Evaluation of the Tailings Storage Facility for the Proposed Savannah Lithium Barroso Mine, Northern Portugal

Report prepared at the request of Povo e Natureza do Barroso
Submitted on June 6, 2021, Revised on June 10, 15 and 29, 2021

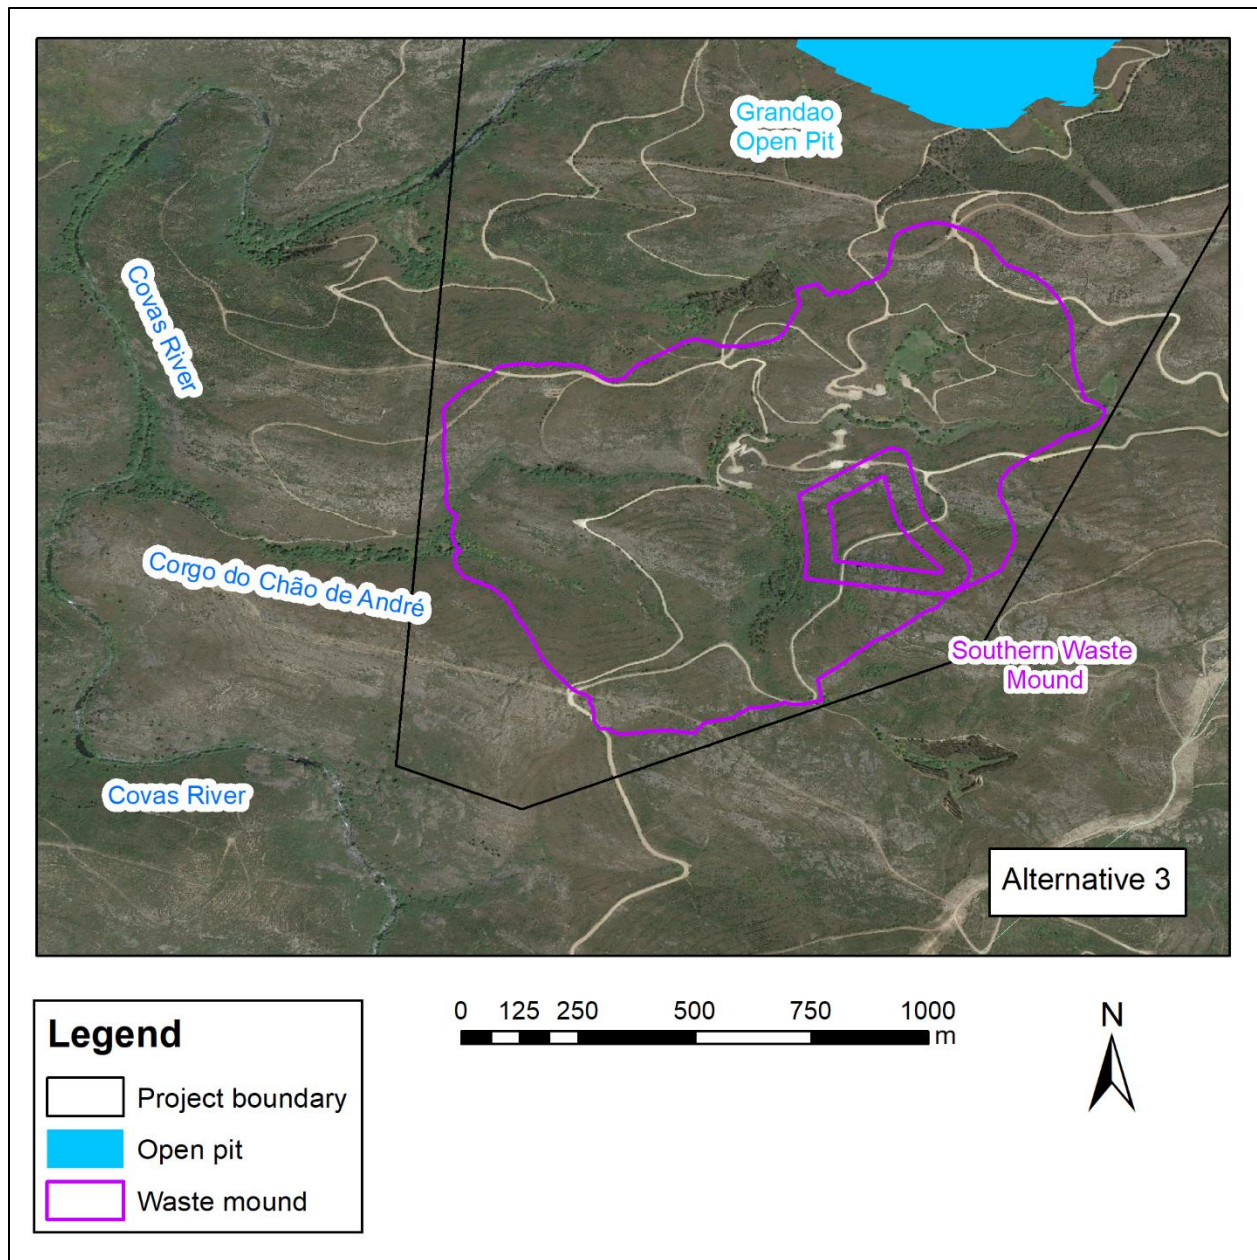
Figure 13. The Google Earth image from May 24, 2019, clarifies that an existing stream network flows through the site of the planned Southern Waste Mound. There is no apparent plan for any canals that would convey the streams and other surface runoff around the waste mound nor any plans for any drains that would convey groundwater from underneath the waste mound. Typically, such a water management infrastructure is needed to prevent rewetting of the tailings. “Corgo do Chão de André” is the local name for the stream that flows westward across the site of the planned waste mound. The outline of the Southern Waste Mound corresponds to Alternative 3 (see Table 1 and Fig. 4c). Mine infrastructure from Savannah Lithium LDA (2020g).

- 8) Although satellite images and the proposal itself show a stream network that flows through the site of the waste mound, there is no apparent plan for any water management infrastructure that would prevent rewetting of the tailings by stream flow, surface runoff or groundwater.
